Re: Lindbergh Drive Drainage Channel
Comparison of Watershed Conditions between 1990 and 2004

DART Notes
Lindbergh Drainage Channel

Town of Addison
Lindbergh Channel Drainage
28 March 2005

LETTER REPORT

EXHIBIT 1
ADDISON AIRPORT
1990 AERIAL

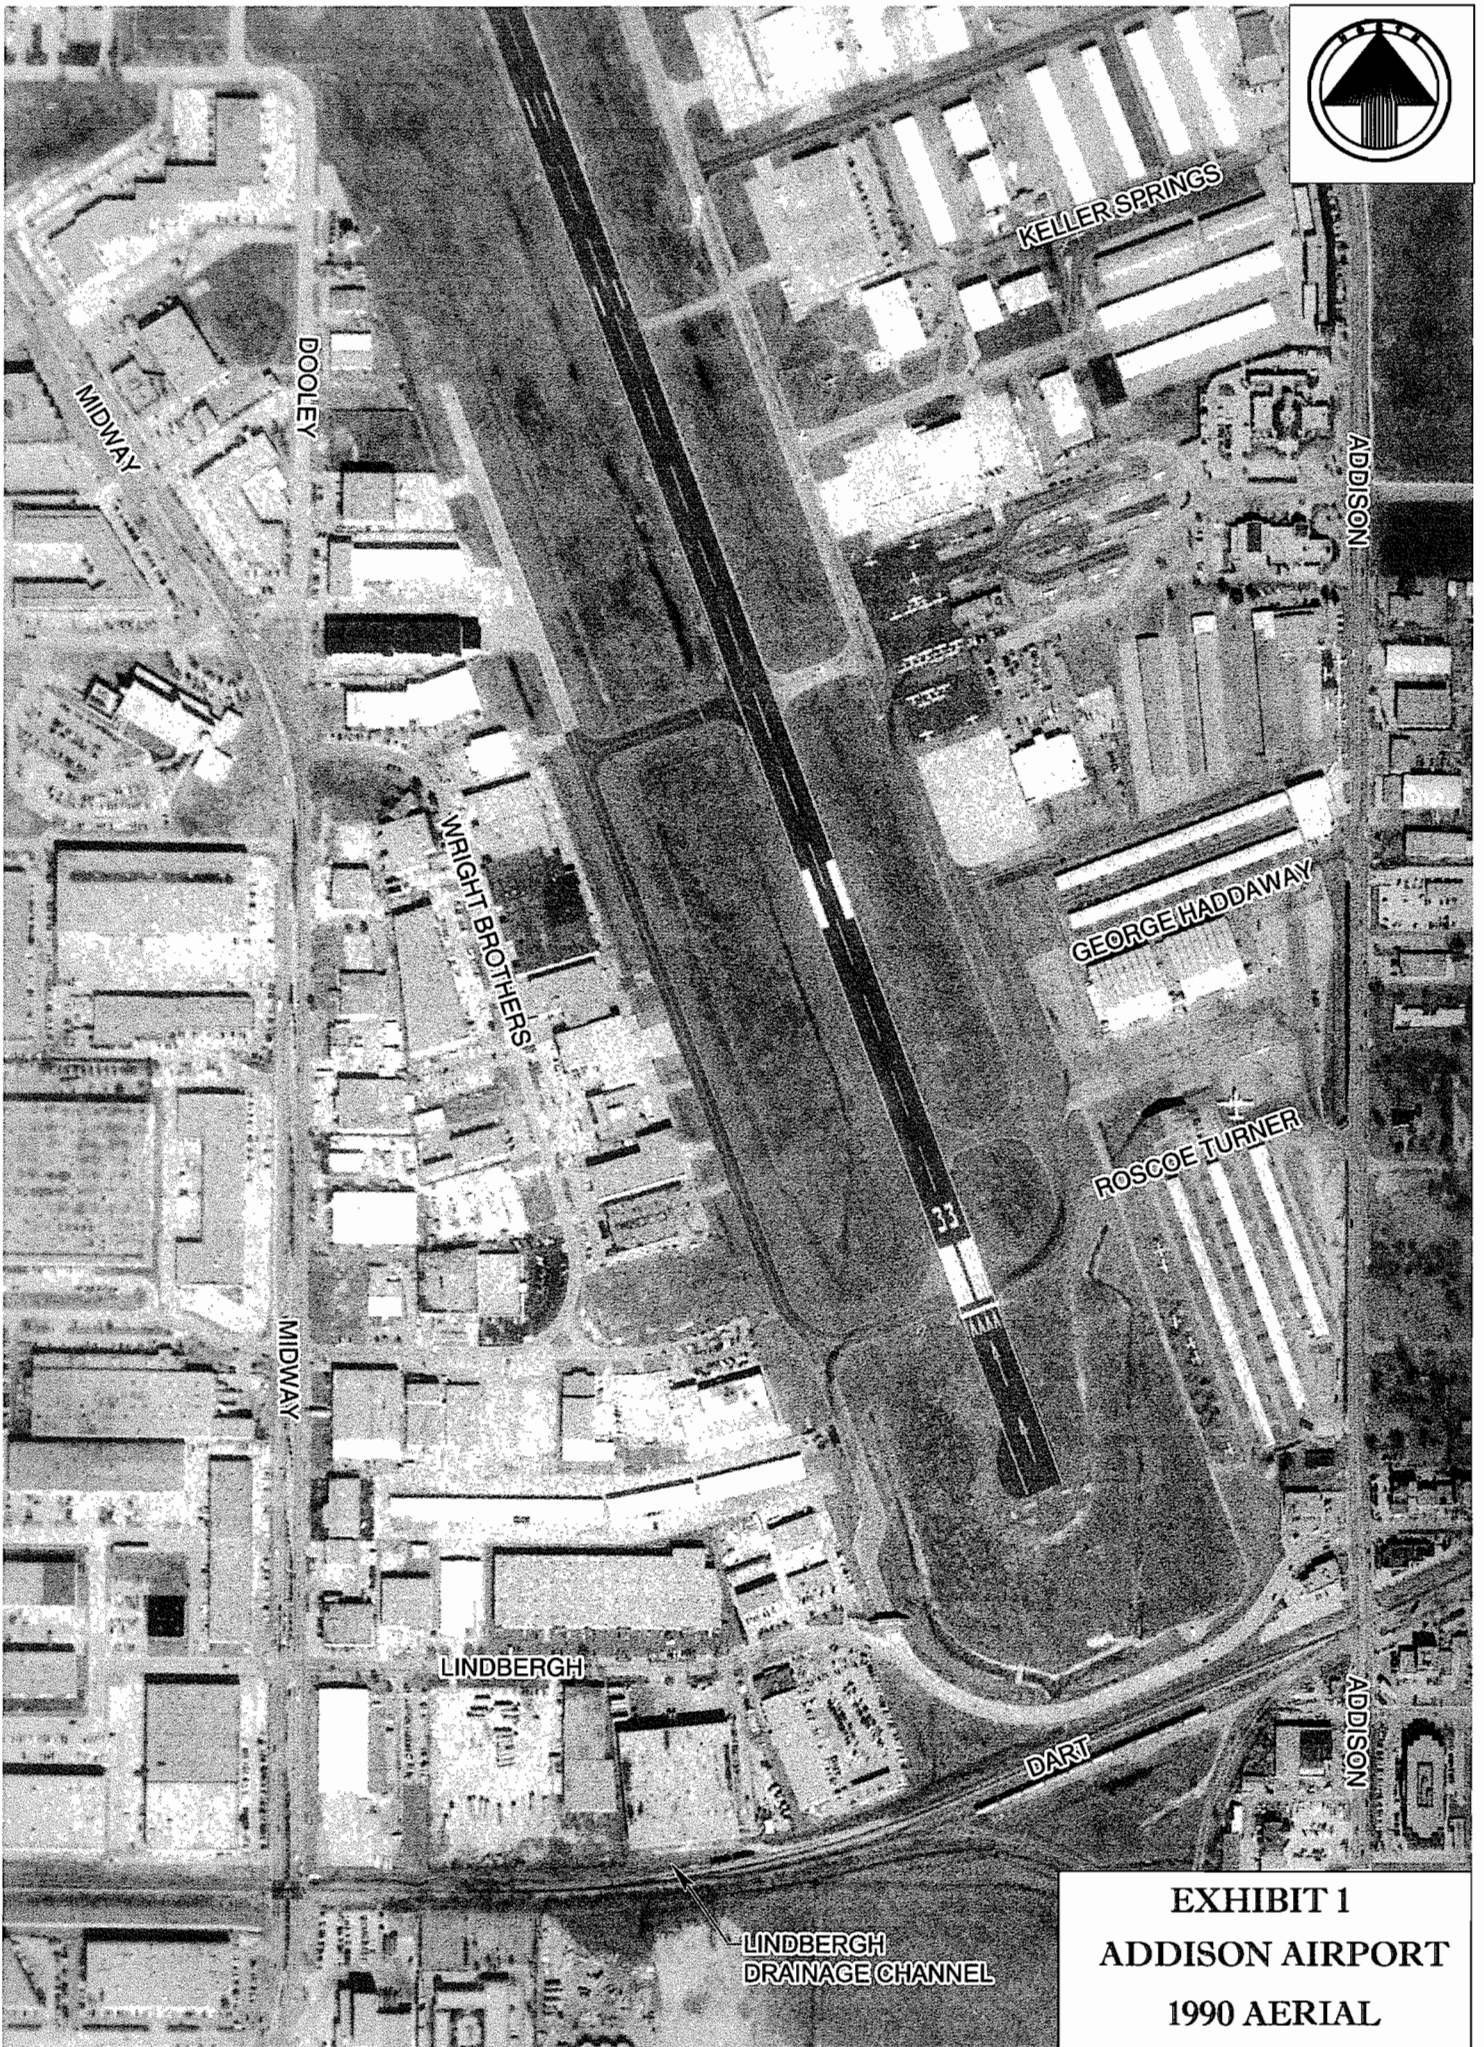
In order to investigate the level of development at the airport between 1990 and today, we acquired aerial photographs of the site from February 1990 (see Exhibit 1) and 2004 (see Exhibit 2). A comparison between these aerials revealed only minor changes in the amount of impervious surface on the airport. For example, impervious surfaces were replaced with grass when the Keller Springs Tunnel was constructed.

EXHIBIT 2
ADDISON AIRPORT
2004 AERIAL

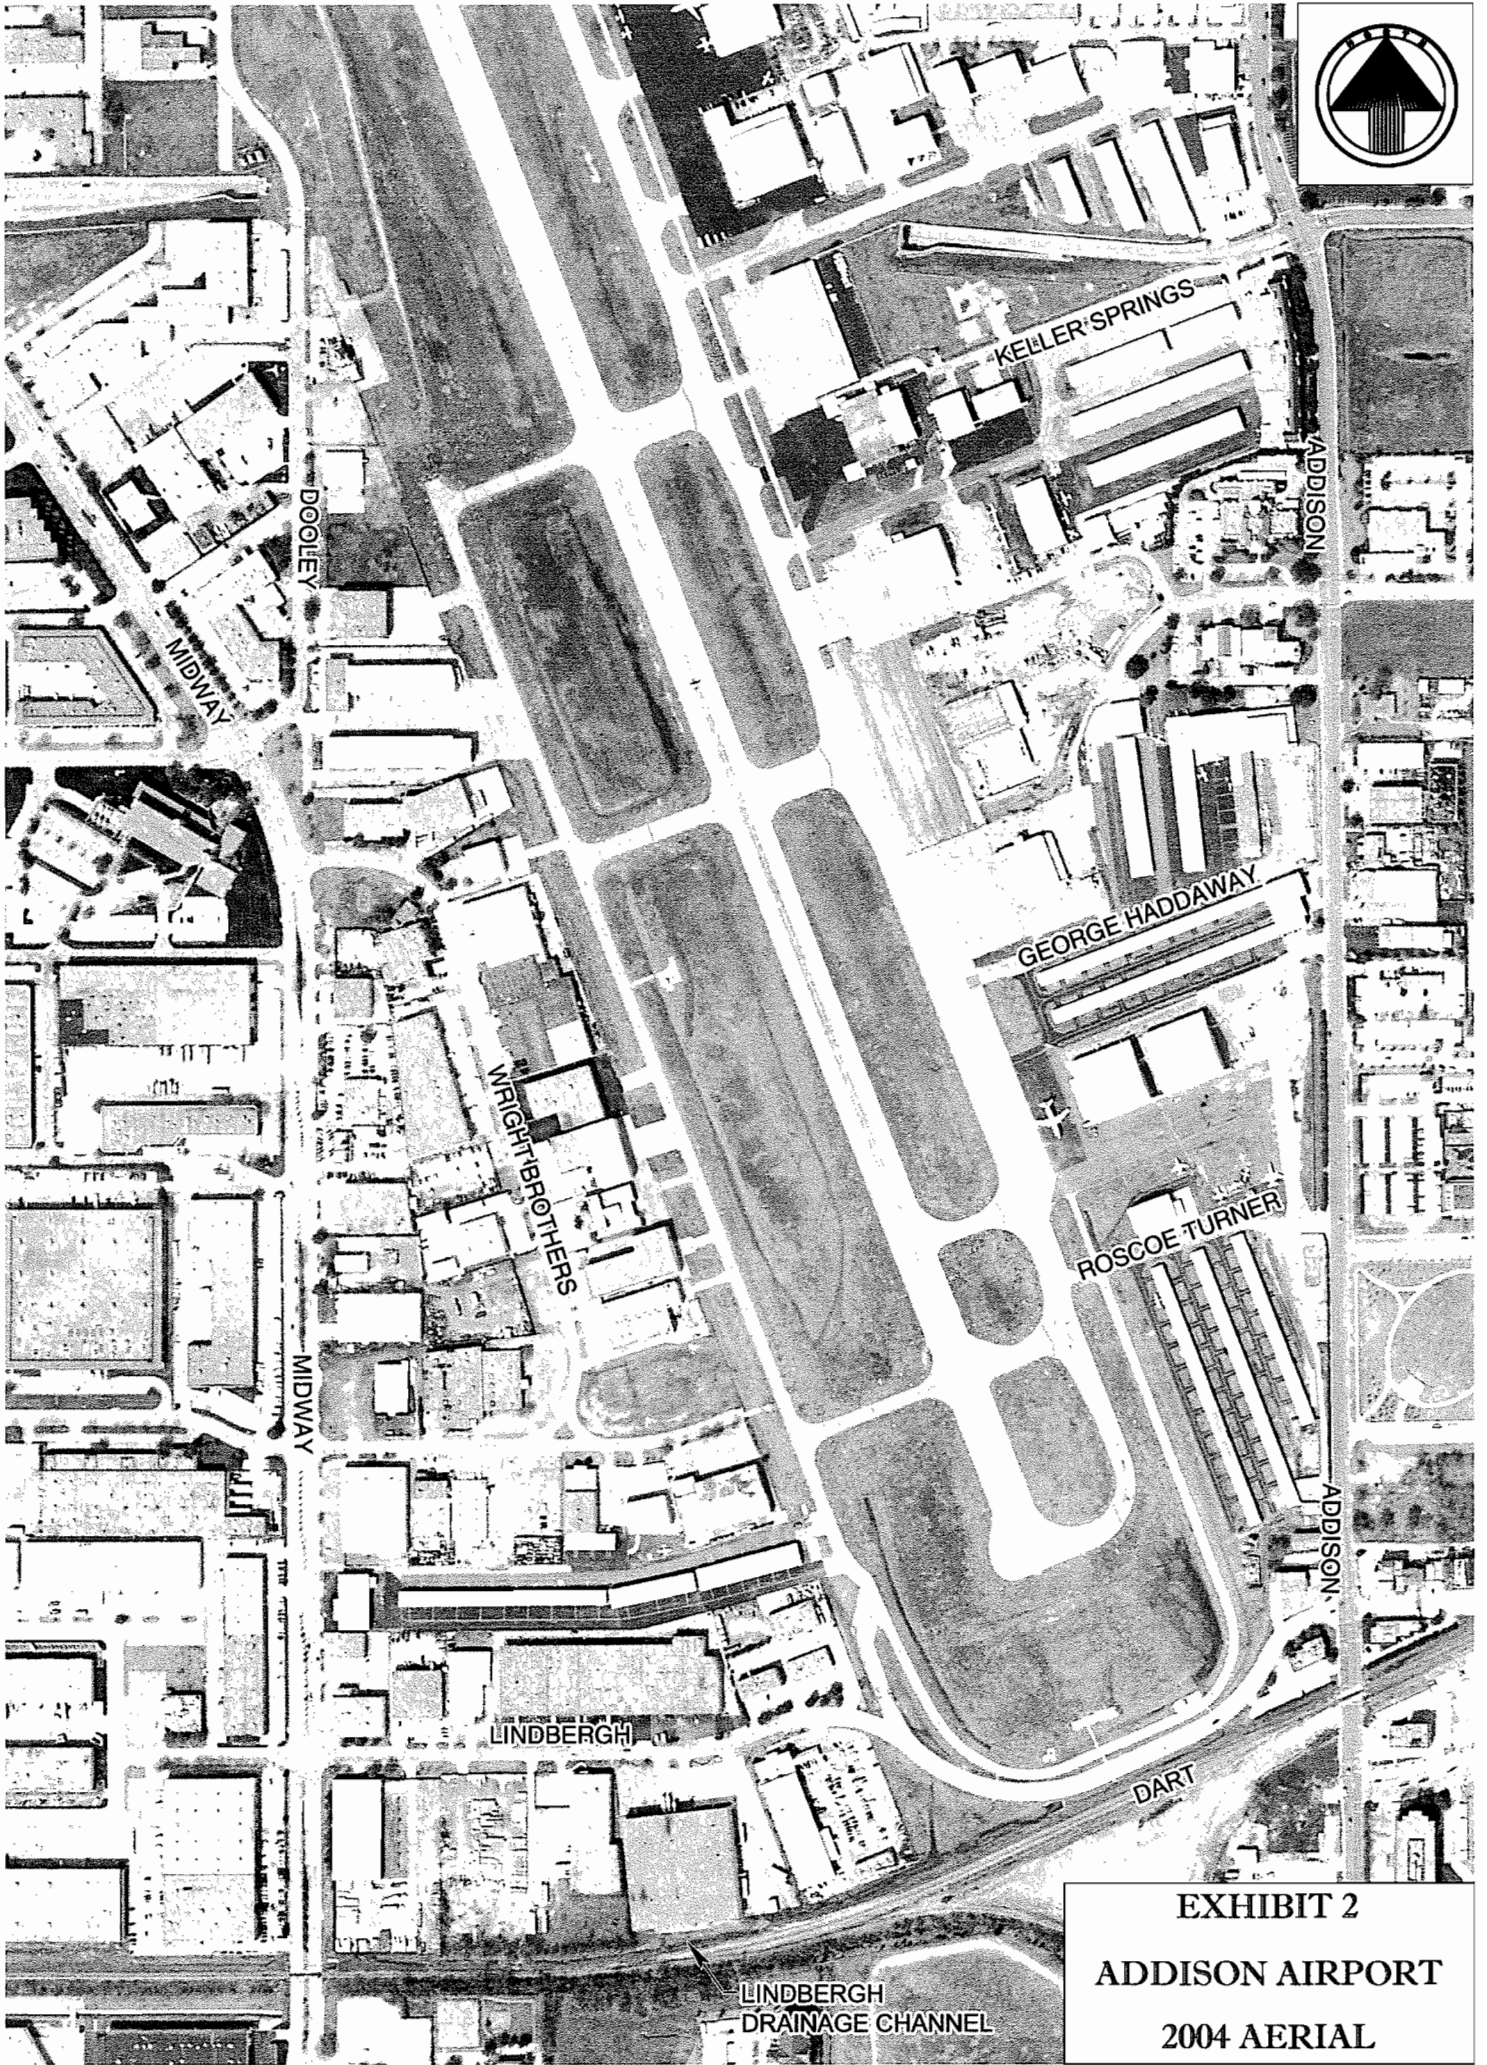
The aerials also show that Lindbergh Drive was constructed in its current location prior to DART's railroad purchase. The existing culverts under Lindbergh are undersized relative to Town of Addison standards, consequently, they result in the detention of stormwater on the Airport.
